## Product Change Notification / GBNG-19TOBI439

CCB 4885 Final Notice: Qualification of CEL-8240 GS as a new mold compound material for selected Supertex CL2xx, CL52xx, LND150, MCP15xx, MCP170x and MCP970xx device families available in 3L TO-92 package assembled at CRTK assembly site.

**CCB 4885**  
**Pre and Post Change Summary**  
**PCN #: GBNG-19TOBI439**

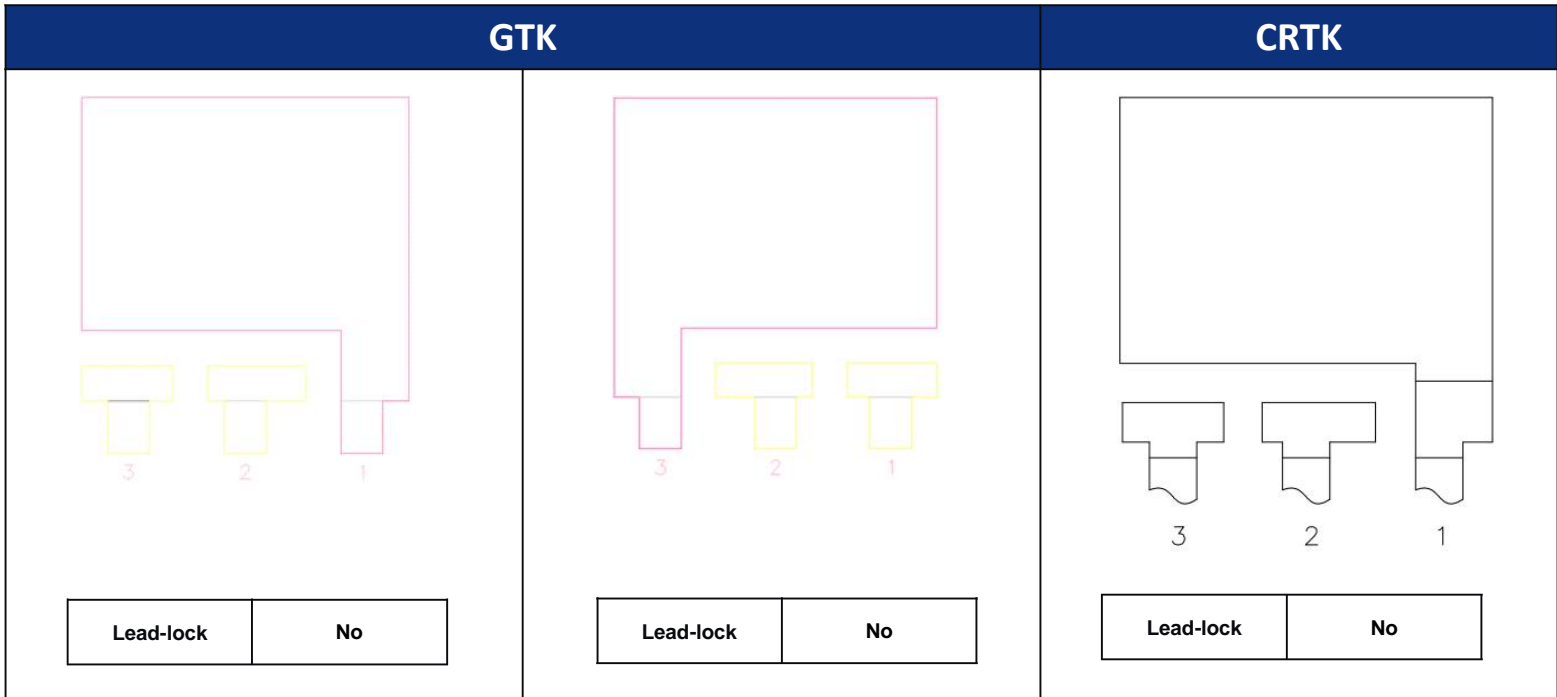
Pre Change		Post Change
Assembly Site		Greatek Electronic Inc. (GTK)	Cirtek Electronics Corporation  (CRTK)	Cirtek Electronics Corporation  (CRTK)
Wire Material		Au	Au	Au
Die Attach Material		CRM1076DJ-G	84-1LMISR4	84-1LMISR4
Molding Compound Material		G600F	EME-G600	CEL-8240 GS
Lead frame	Material	CDA194	A194	A194
	Lead lock	No	No	No
	Design	See attached Pre and Post change comparison		
Package Lay-out		See attached Pre and Post change comparison

# Lead Frame Comparison

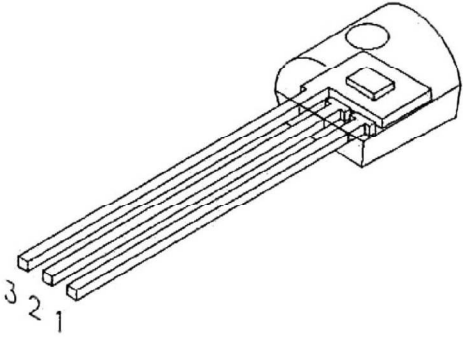
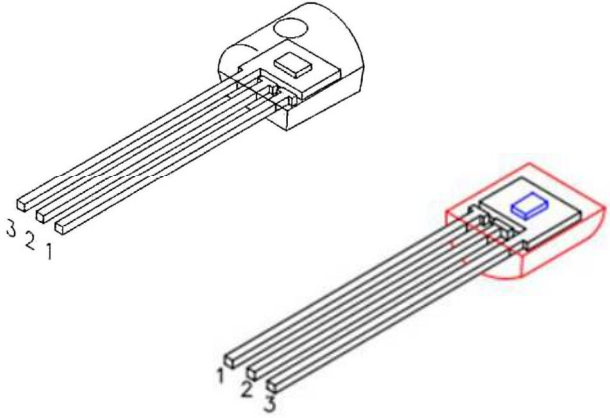
Note: Mold compound material fills the leadlock hole, which provides improved protection against moisture penetration along the edge of the leads (pins) of the package.
